Shippensburg University

SUPPLEMENT 1 Electrical Coordination Study

Professional:
Entech Engineering, Inc.
4 South Fourth Street
P.O. Box 32
Reading, PA 19603
Telephone: 610-373-6667
Fax: 610-373-7537
www.entecheng.com
Entech Project #: 2184.22

August 24, 2004

TCC Name: TR2-8 C.G
Rev. 0.0
Date: March 12, 2004

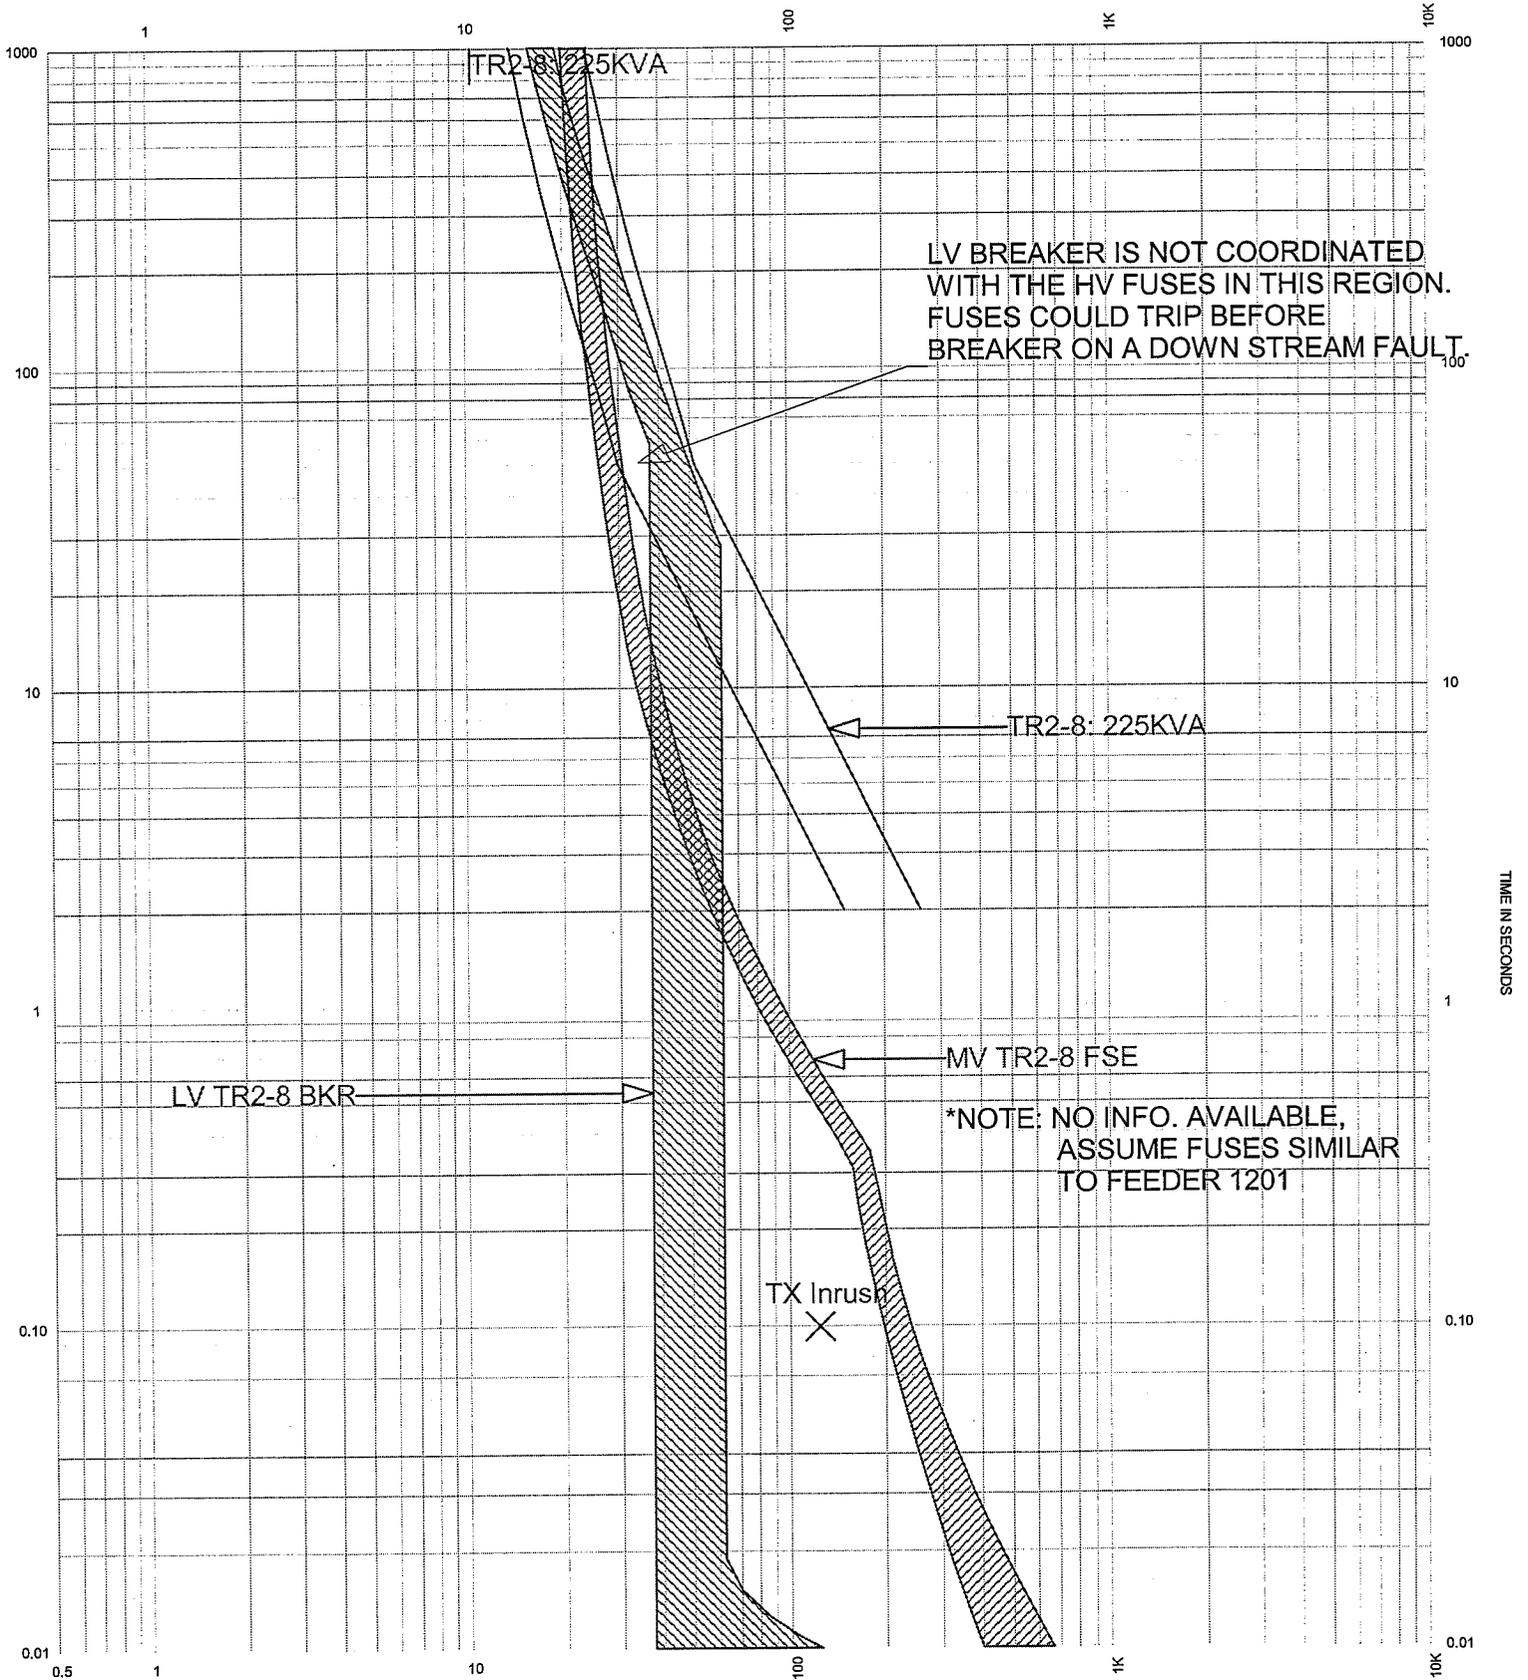
TCC TR2-8 Cora Grove Spiritual Center: The actual size of primary fuses for TR2-8 could not be determined during our surveys or from the information provided by the University. Therefore, a fuse size and rating (class C, 12A) was assumed based on similarly sized transformers on the campus. Based on analysis using this assumed data, the secondary main circuit breaker and primary fuses for transformer TR2-8 are not coordinated in the short time region. Coordination could be improved by replacing the existing secondary main breaker with a static trip (solid state) main breaker with long-time, short-time, and instantaneous pickup and delay settings. However, the actual rating of the primary fuses should be verified before any changes to the system are made.

TCC Name: TR3-1 EZRA LEHMAN LIBRARY
Rev. 0.0
Date: March 12, 2004

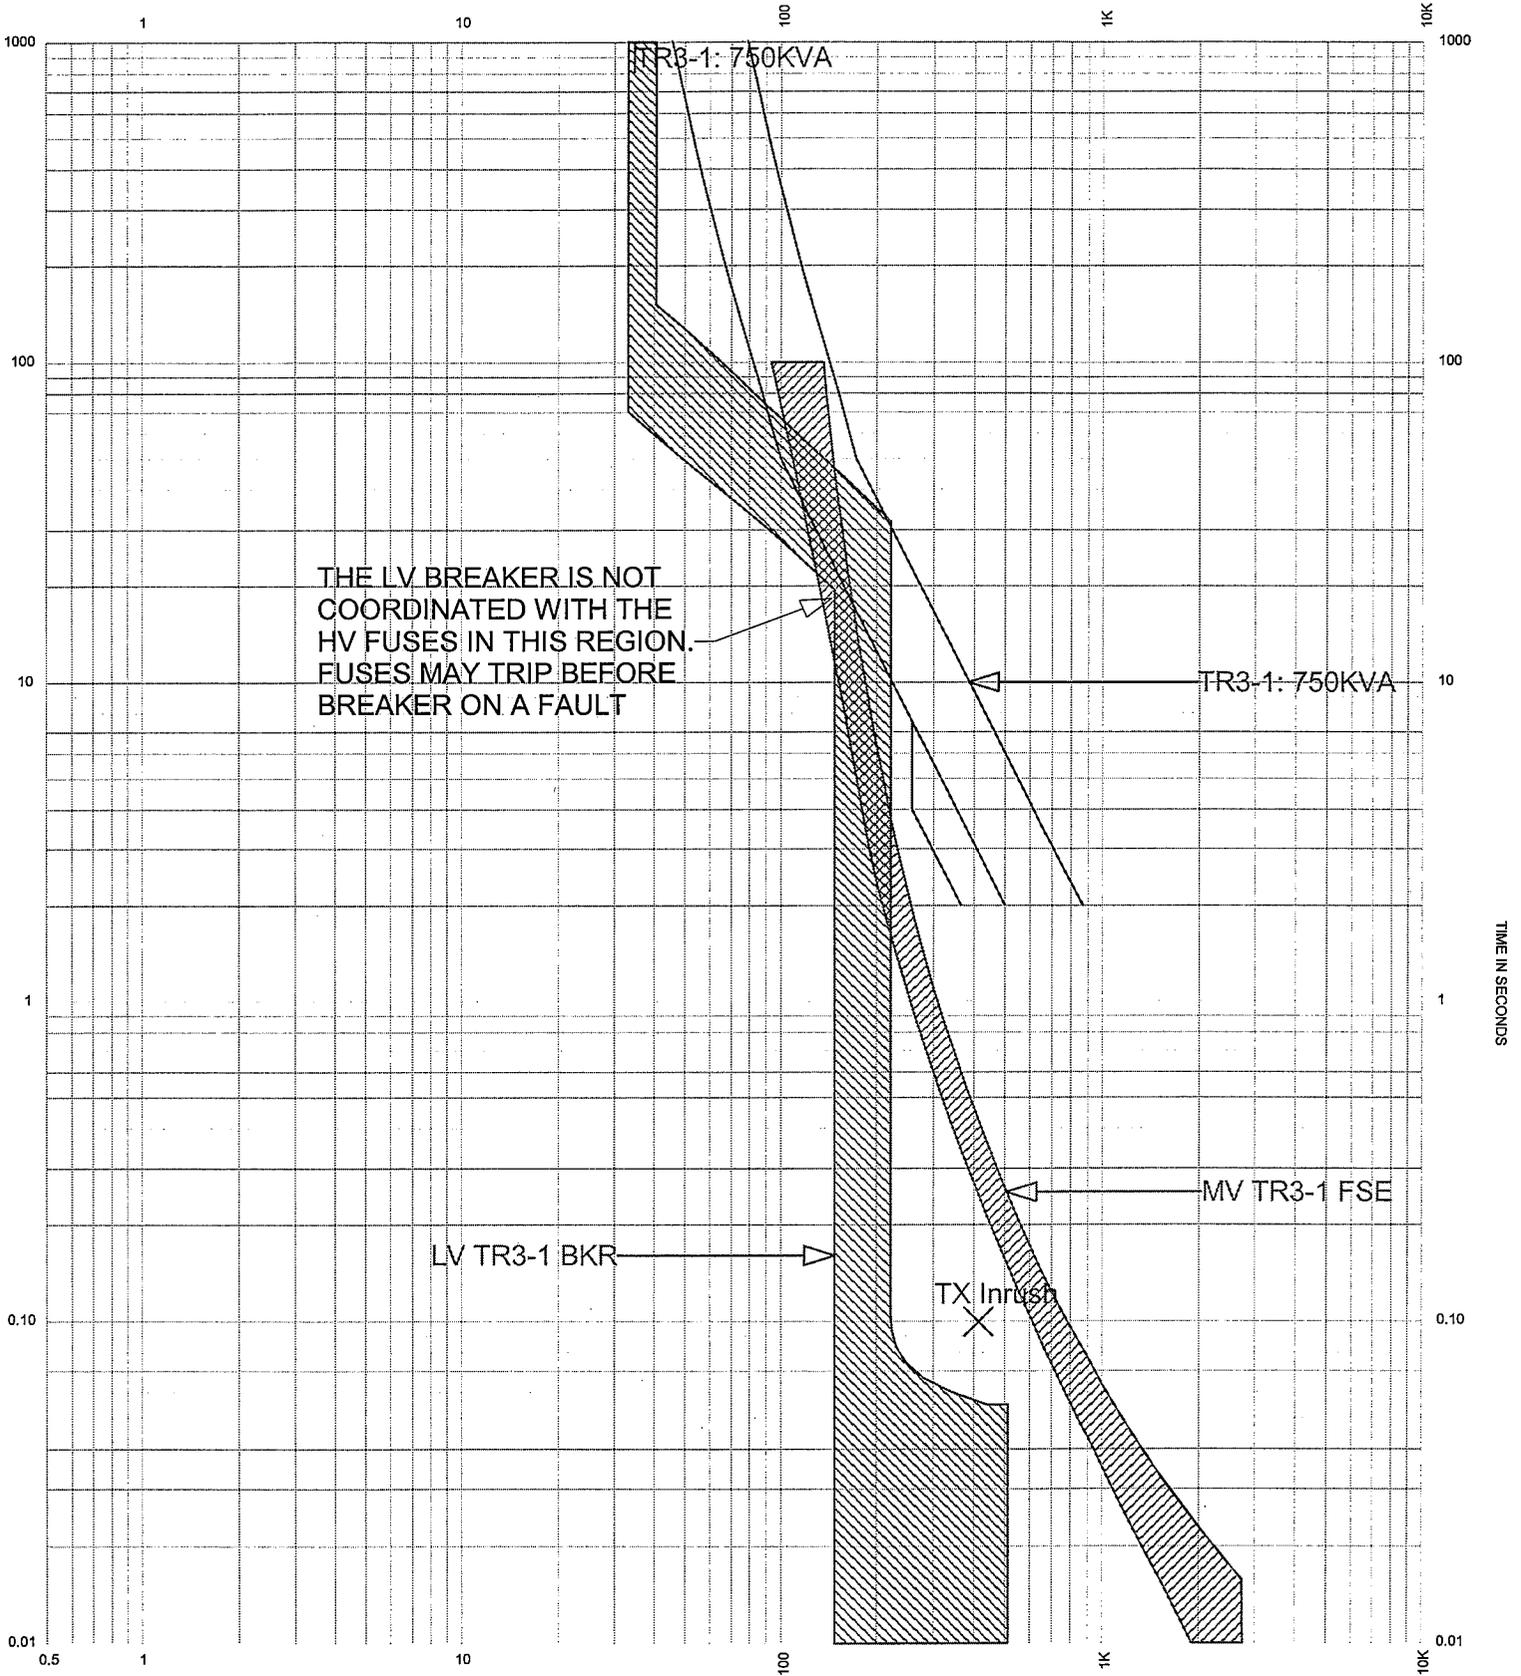
TCC TR3-1 Ezra Lehman Library: In the short time region, the secondary main circuit breaker is not coordinated with the primary fuses for transformer TR3-1. This could result in the primary fuses tripping before the secondary breaker on a down stream fault. A static trip (solid state) breaker with long-time, short-time, and instantaneous pickup and delay settings could be installed in place of the existing secondary main circuit breaker. The addition setting would allow for better coordination with the up stream primary fuses.

TCC Name: TR3-4 FRANKLIN SCIENCE CENTER
 Rev. 0.0
 Date: March 12, 2004

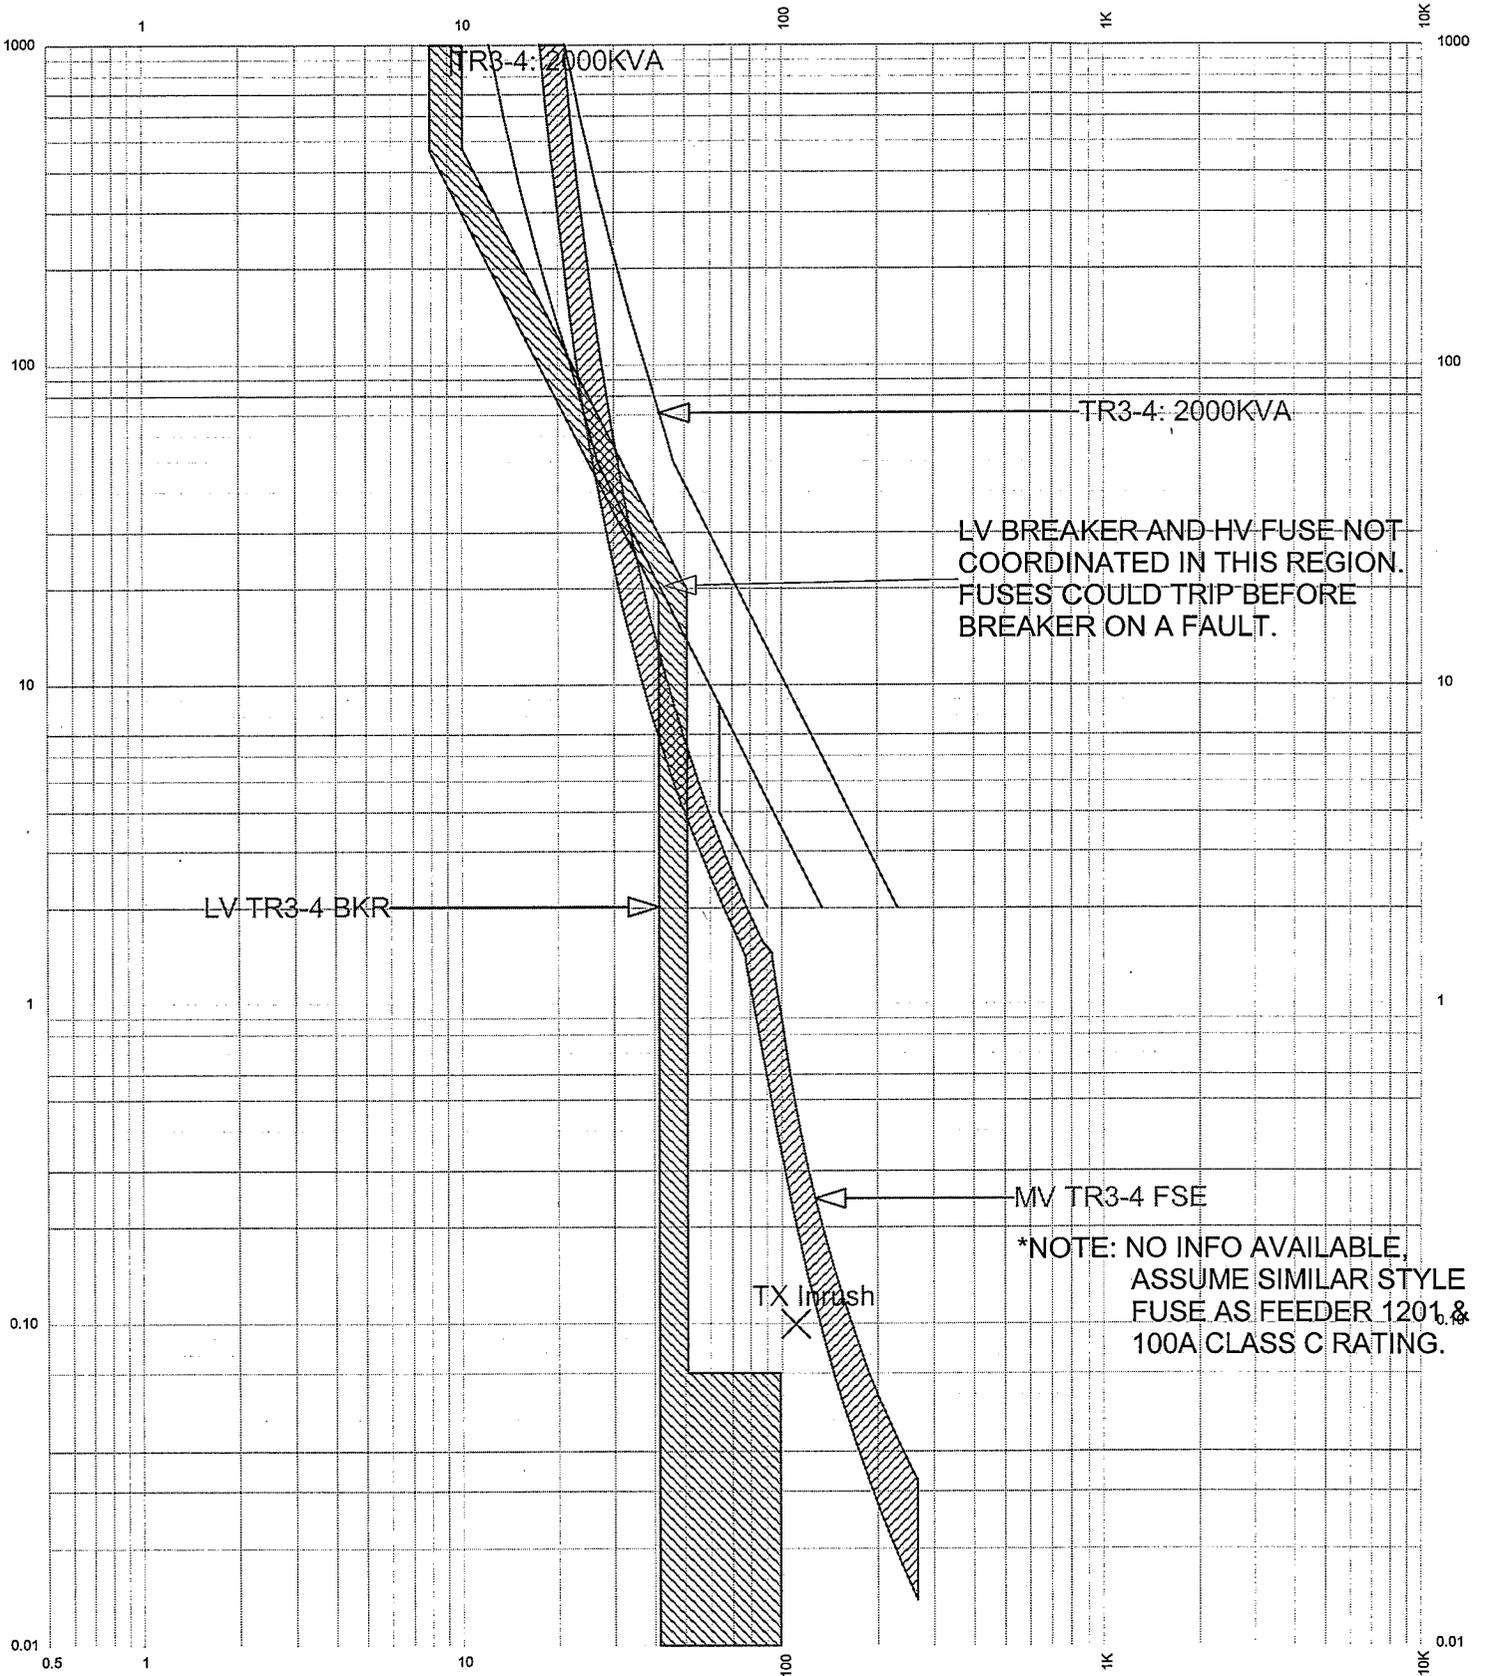
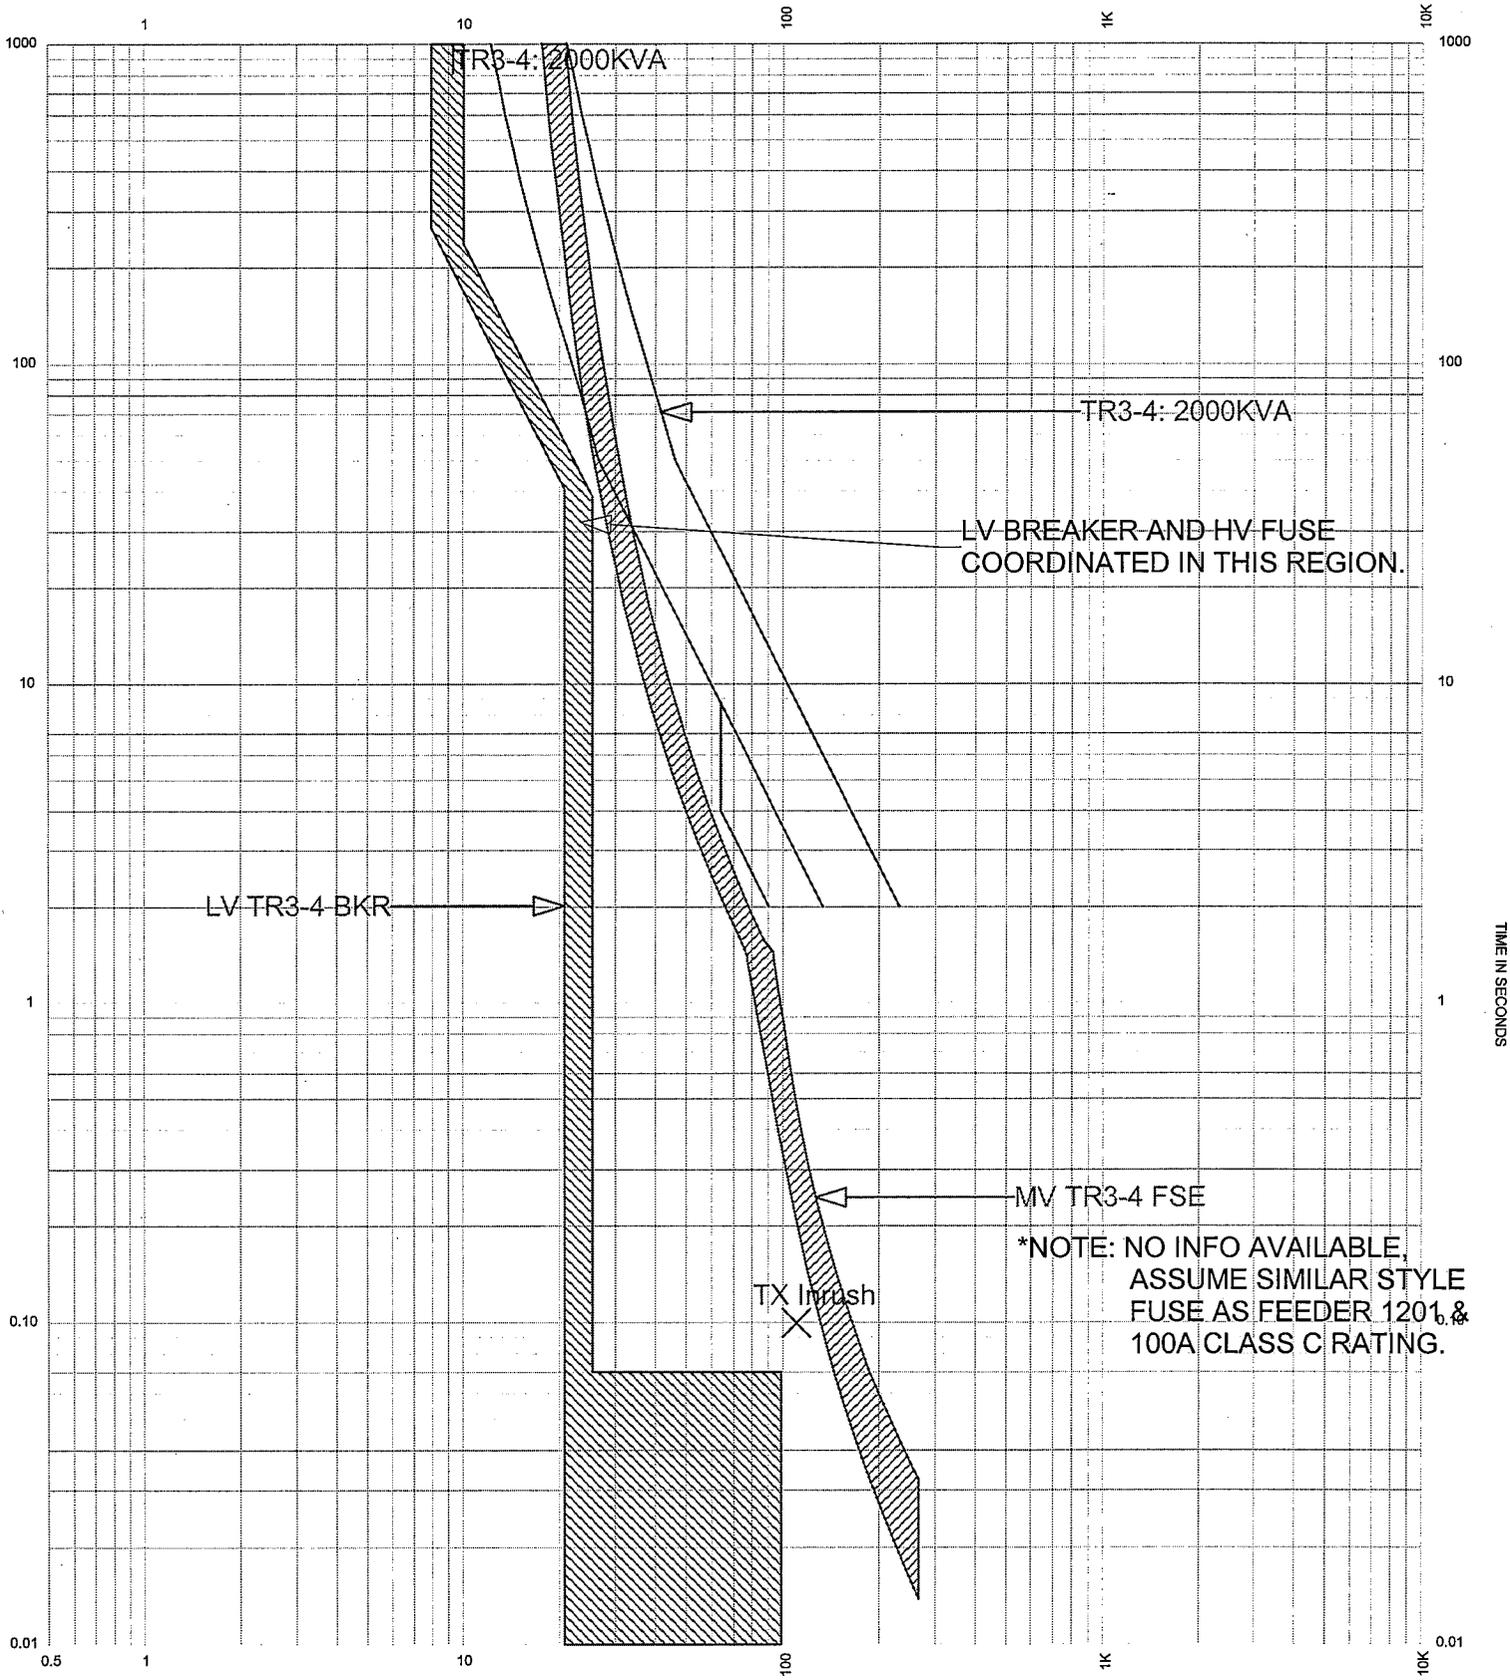
TCC TR3-4 Franklin Science Center: No information was available on the actual primary fuse sizes and ratings. Therefore, a similar style fuse (class C) to those used elsewhere on Campus was assumed with size (100A) based on the transformer kVA rating. With this assumed fuse information, it is possible that the secondary main circuit breaker and primary fuses are not coordinated. Better coordination may be achieved by resetting the following (refer to TCC TR3-4 Franklin Science Center in Appendix B):

1. The longtime (LTD) setting from 24 to 12.
2. The instantaneous (INST) setting from 6 to 3.

Before changing any settings, the actual size of the primary fuses should be verified.
